## Tarrawonga Modification 7 – Life of Mine

People for the Plains is a group of people from the Narrabri district interested in the impacts from coal and coal seam gas and we would like to respond to the Tarrawonga Modification 7 – Life of Mine.

Below is figure 5-2 from the Modification Report to help illustrate this point:

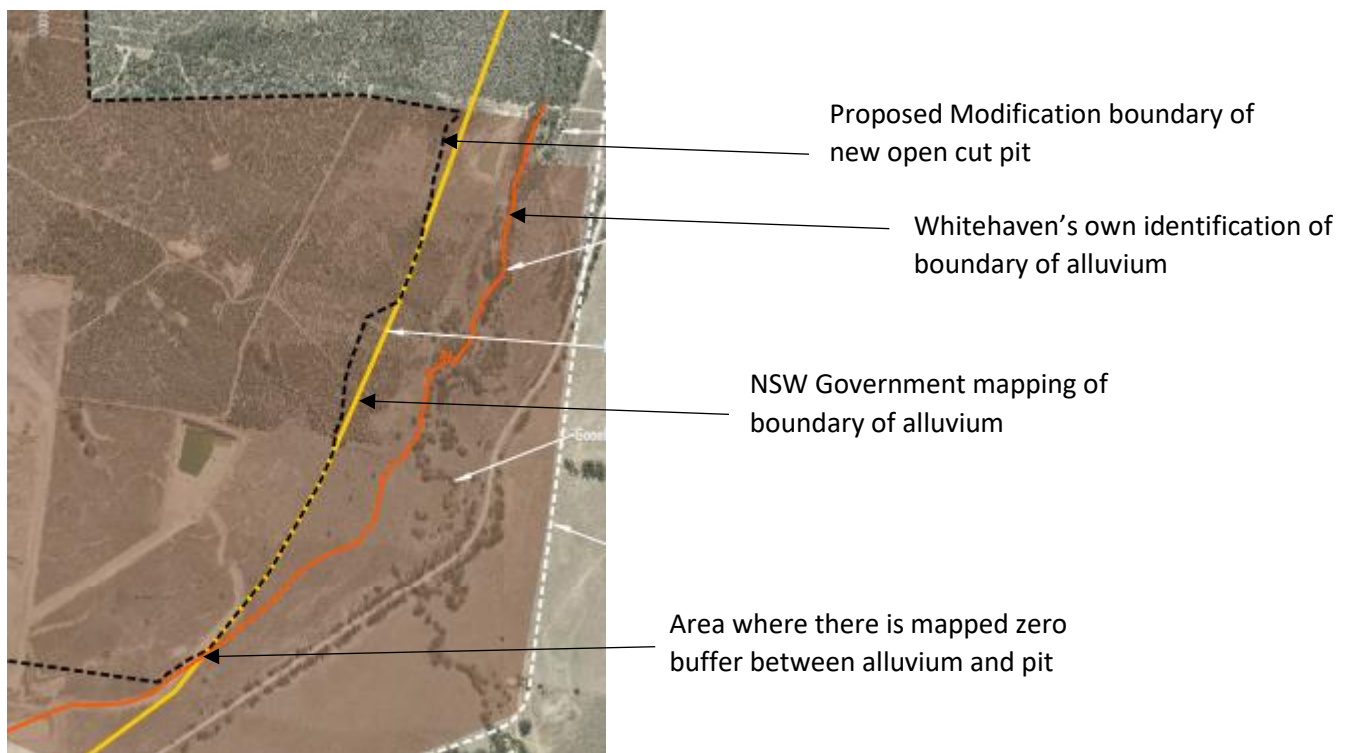
To avoid the expense of the low permeability wall that was part of the original Consent Conditions for Tarrawonga, this Modification proposes to bring back the boundary of the open cut pit, away from the alluvium. It is extremely concerning that the proposed boundary in this Modification sits exactly on the boundary of the alluvium as mapped by NSW Government and shown in Figure 5-2. These are simply lines on a map, interpolated from widely spaced exploratory bores. As groundwater drillers will attest, variances can occur within a few metres. In other words, water can be found at a particular location but not at a location a few metres away. A line on a map is not an accurate guide for locating the edge of a 300 meter void. Whitehaven's conditions of consent on this Modification should ensure at least a 500 metre buffer between the mine and the Government's mapping line of the edge of the alluvium.

It is worthwhile noting that Whitehaven's own mapping puts the line of the aquifer further away from the proposed pit edge but it is unclear why, or how Whitehaven came to this conclusion. There is a reason that the initial consent condition forced Whitehaven to use a low permeability wall – it was to stop pit inflows from the alluvium aquifer. It was to stop precious alluvial water from pouring into the pit at Tarrawonga. This consent condition should not be modified.

Should Tarrawonga accidentally interfere with the alluvium, should their line on a map prove to be less than totally accurate, this could well provide water to Vickery with Whitehaven simply outbidding farmers in the market to access more Zone 4 licences to make up for the “accidental” take into the pit.

The precautionary principle should be applied and the mine kept at least 500 m away from the aquifer boundary as mapped by the NSW government, not by the company. Science to validate the lines on the map would be a useful addition to the consideration.
